SPO50015Q0008
QUESTIONS AND ANSWERS

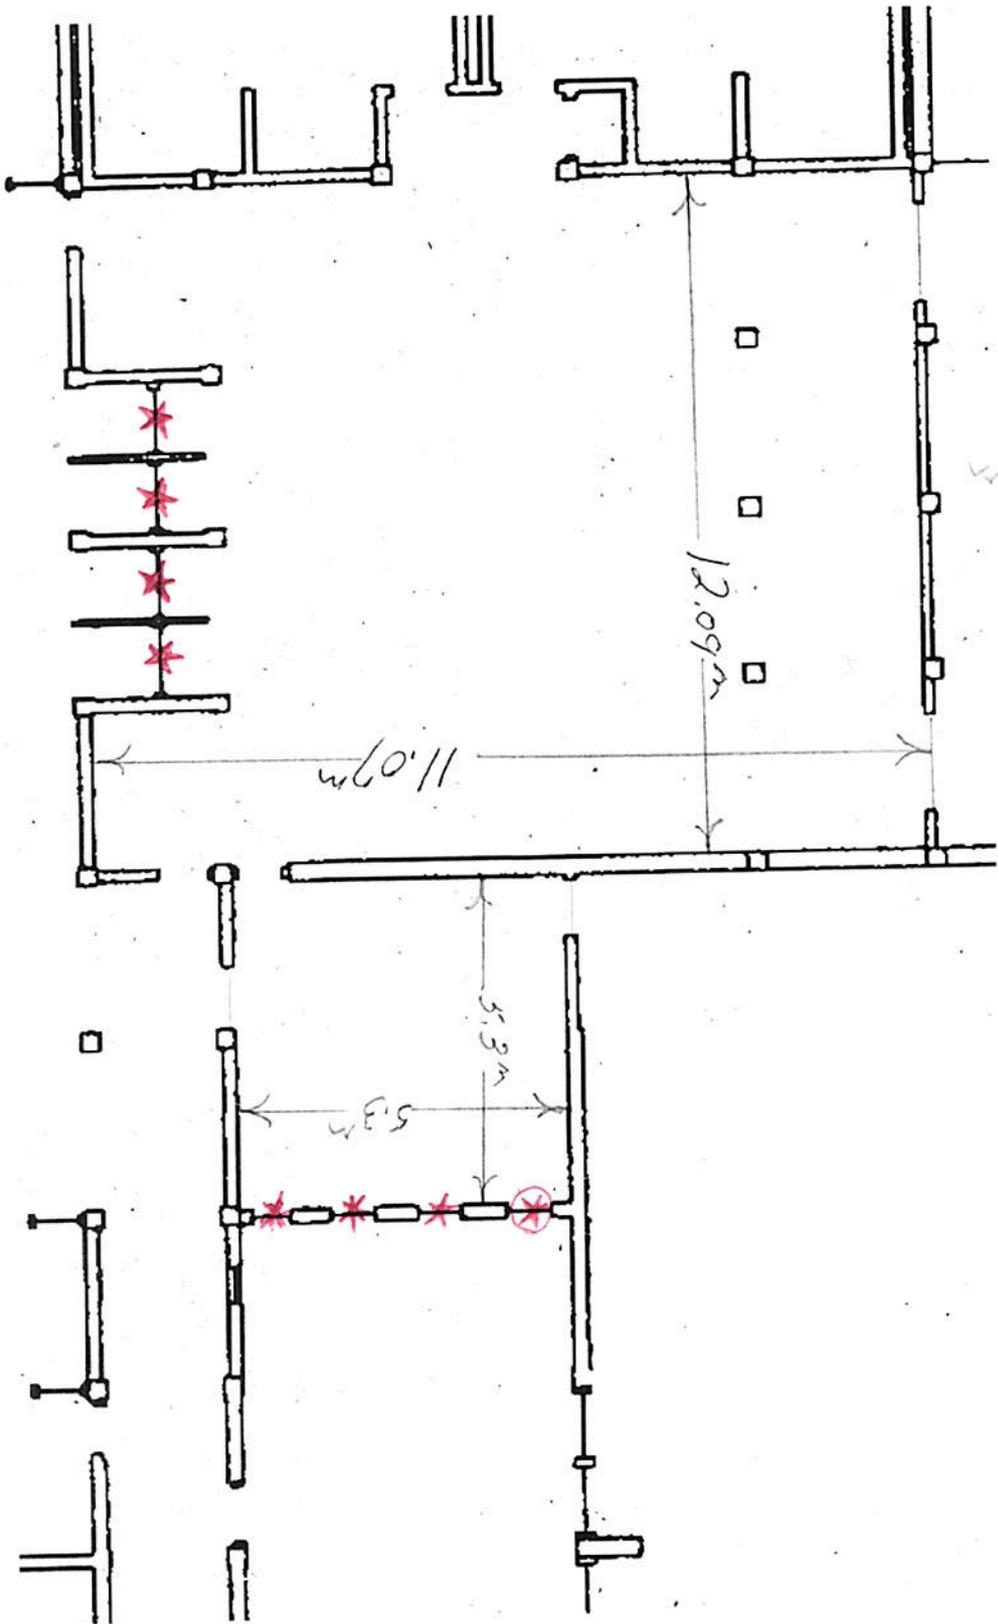
The two areas have two independent systems. These two independent systems consist of a windows intercom system for each window as well as an amplifying system for the sound system installed in the waiting area. Concerning this last part we need to know the following:

For each area (small and large) please indicate on a blueprint where can the contractor install or place the amplifier, as well as the zone interface, so we can have an estimation of the length of cable needed from the paging desks to the amplifier as well as from the amplifier to the loudspeakers.

Also we need to know if the location where the equipment will be placed is an open or a closed area such as a technical room. If it is in a technical room, will the contractor have permission to drill a hole to pass the cables from inside to outside?

Do you have a map of this sections?

Where is to install the rack mounting with the AV equipment?

The amplifier will be placed in a closed electrical closet, and drilling is permissible.

The distance from the electrical closet is:

Closet to ACS office doorway – 15.6M

Closet to wall near the NIV windows – 26M

Closet to the end of the last visa window – 37M

If the amplifier does not need a dedicated circuit, it can be plugged into the wall outlets.

Attached please find a drawing of the area.

See attached drawing.
